Venice Neighborhood Council

Land Use & Planning Committee (LUPC) STAFF REPORT

City Case No: APCW-2025-4181-CDP-SPPE-SPPC

Address of Project: 606-654 Venice Blvd.

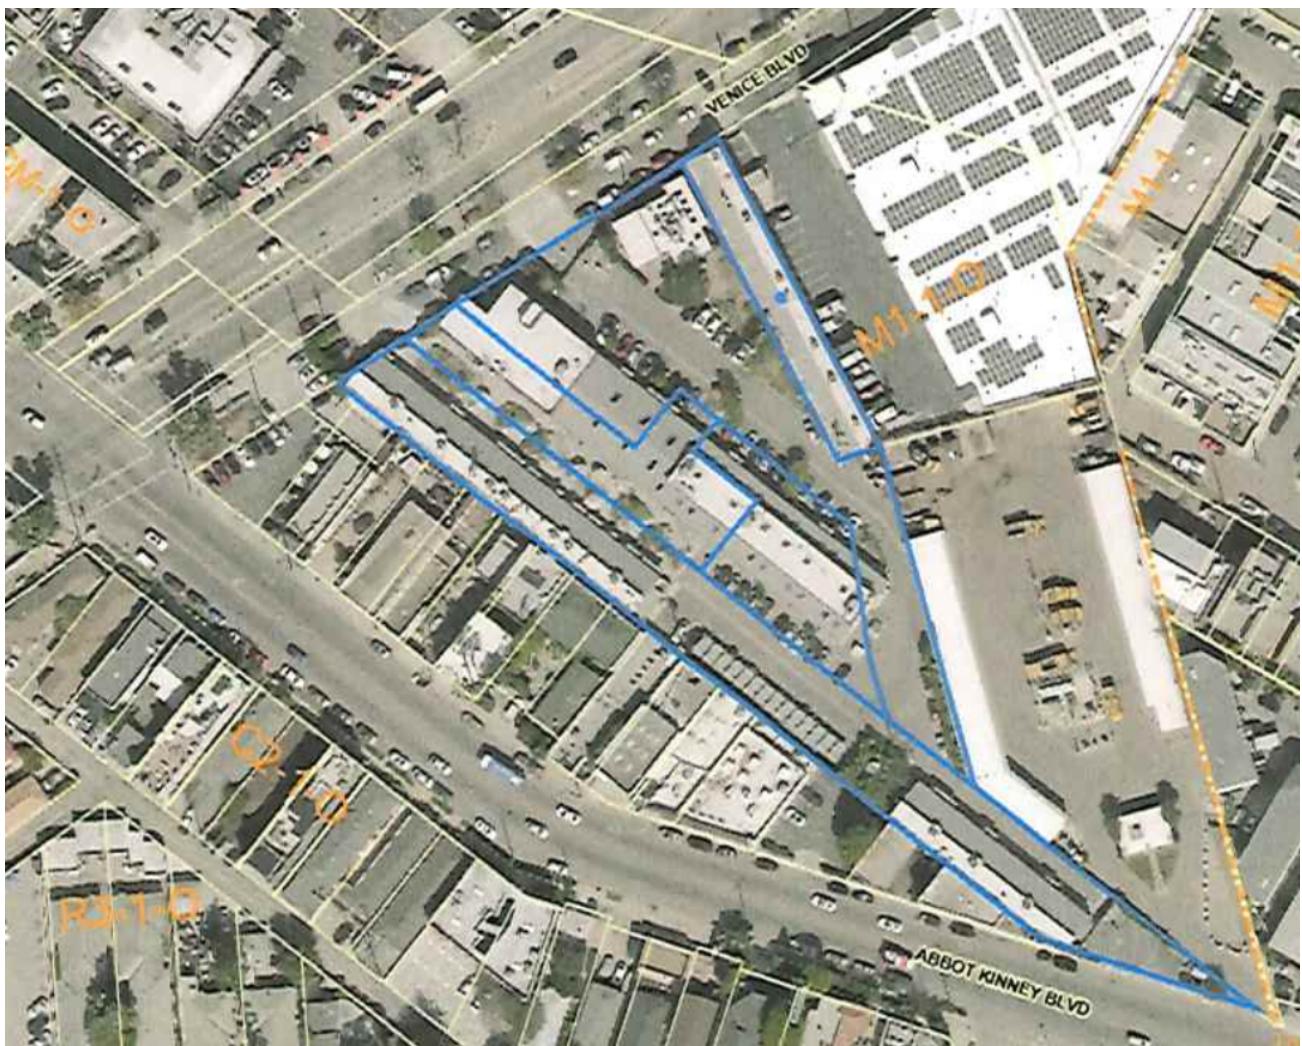
Project site is identified as five blue boxes representing five unnumbered lots on the ZIMAS survey (Exhibit A.3). Project is associated with eight addresses in City Planning website. Even though VCZ Specific Plan Section 9.A.1.e.2 does not provide for consolidation of this many lots, Applicant states that LA City Planning is satisfied with the available evidence that the lots are legally consolidated. Lot consolidation was accepted prior to 2015 cases DIR-2015-3612-CEX and DIR-2015-3426-CEX. Therefore, zoning approval is inferred.

D. Floor Plans

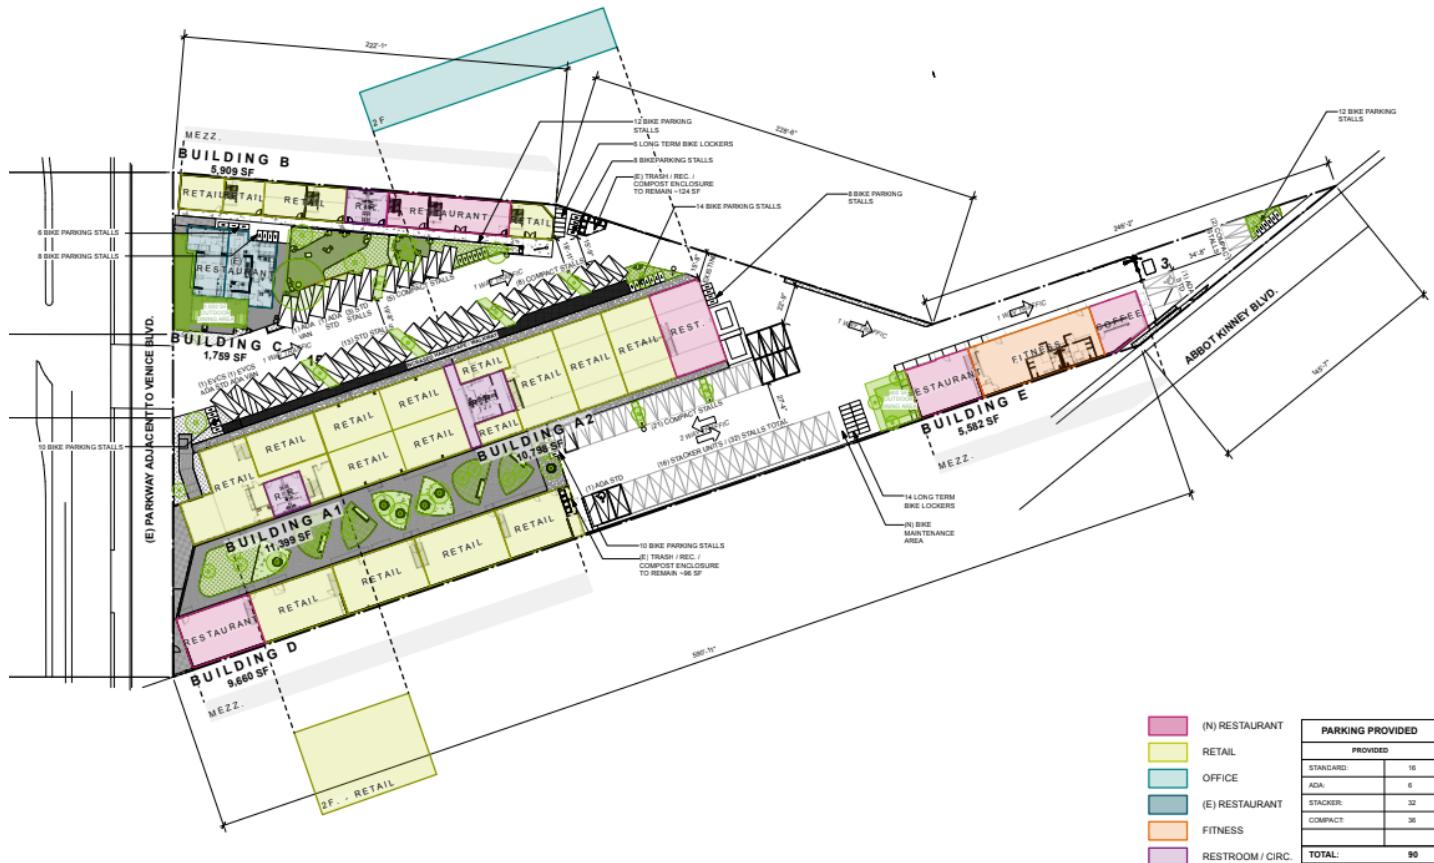
Interior build-out is not a part of this planning consideration.
No increase in floor area is presented by Applicant to Planning.
